Our Case Number: ABP-317560-23

Re: Proposed windfarm development including 13 no. wind turbines in Bunnyconnellan, Co. Mayo and hydrogen plant in Castleconnor, Co. Sligo.
Carrowleagh, Bunnyconnellan, Co. Mayo and Curraun, Castleconnor, Co. Sligo.

Submission from the Mayo, Sligo Energy Concern Group

example of how plots were divided.

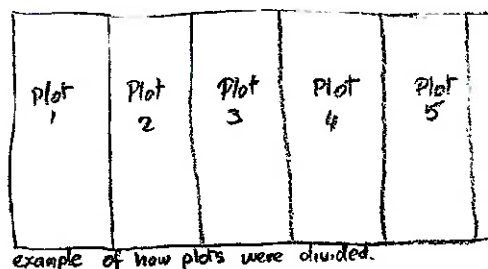
Concern: - This is totally incorrect information in relation to size and number of the existing plots. The Land Commission allocated turbary rights and commonage on Kilbride Bog (also referred to as Carrowleagh). This bog is where the applicant proposes to develop a wind farm. It is our understanding that turbary rights to a plot of bog, remain in place for that entire plot, (i.e. bank of turf and cutaway area), until such time as the entire plot is cut away. Rights of commonage cover the surface area of the bog for grazing. The Land Commission decided that 'Fee Simple' comes into play on each plot that is entirely cut away and no peat remains for harvesting. This means effectively in the case of this bog, that commonage owners have the rights to the plots that are fully cut away, but not plots that still have peat remaining.

- On Kilbride Bog 'Fee simple' only comes into play on each plot that is 100% cut away. Fully cut away plots then fall under Fee simple
- Turbary RIGHTS Remain on each plot where there is still uncut peat & this includes the cutaway portion of each plot in turbary rights.
- Fee simple rights go to Commonage owners

Sample of how bog plots have been cut in Kilbride bog*

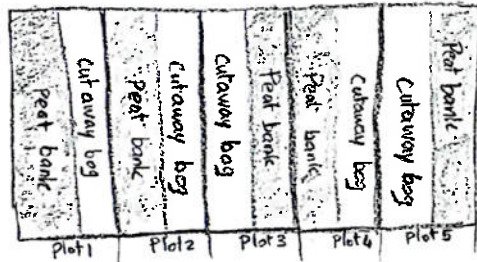
- Turbary Rights to harvest Turf Plots were allocated by number to houses in the area & many to Ballina Town householders
- Bog plots are not typically 50m x 180m as stated by the developer
- There are not over 620 plots as stated by the developer.

- Turbary Rights owners have cut turf on their plots. There is no rule for where they cut on their plots so the pattern throughout the bog is that of plots with strips of peat with strips of cut away bog.
- Therefore Fig. 5.3 does not represent this correctly. Figure 5.3 Habitats map is misleading and shows vast areas of cutover bog.

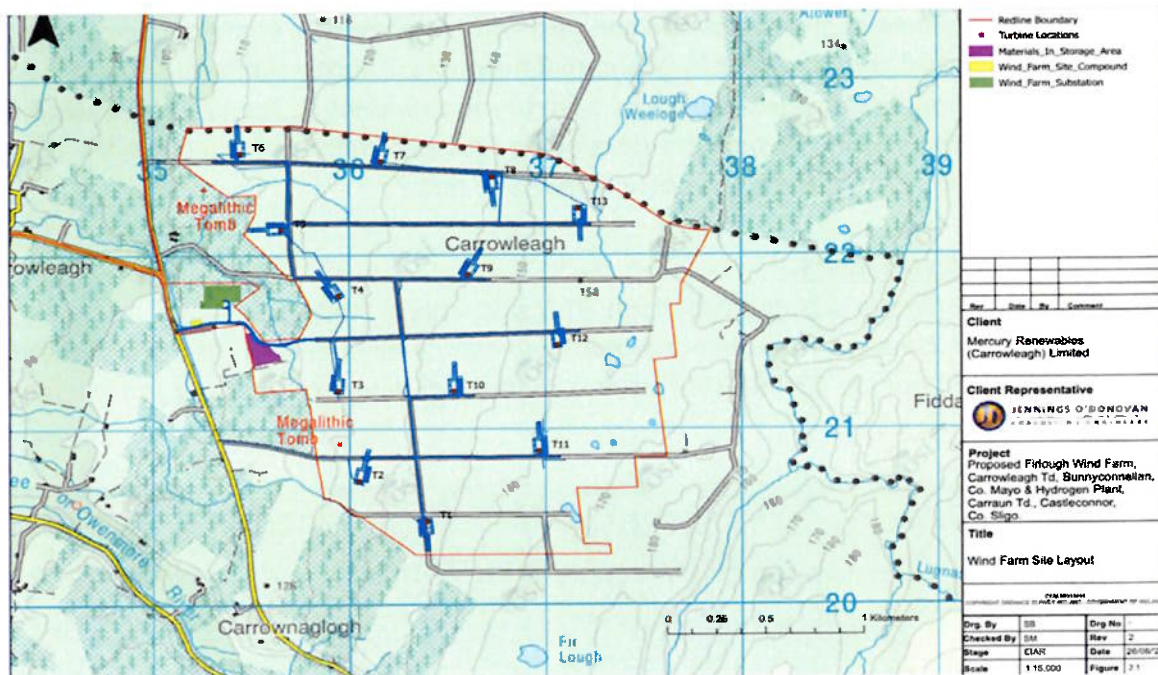
We are gravely concerned in relation to access for approximately 323 turbary plot holders since T2 and T4 have hardstands that traverse two of the access roads to the bog. Firstly, the planning drawings do not show these hardstands and they are portrayed differently in the planning drawings to other turbine bases and hardstands. T4 is not shown in its entirety on a single drawing sheet, in the same manner as the other turbines. Secondly, during the construction phase, it will not be possible to travel over these stands. It is also questionable as to whether people with turbary plots will be able to safely drive over them, with heavy loads, following completion of the project. There is no evidence of consents being in place for turbary plot owners in relation to access to their bog plots throughout the year.

Concern: - It is difficult to understand what is meant by the above paragraph when it is read in conjunction with the below Wind farm Site Layout. Why is there no mention of T5? We seek clarification of this.
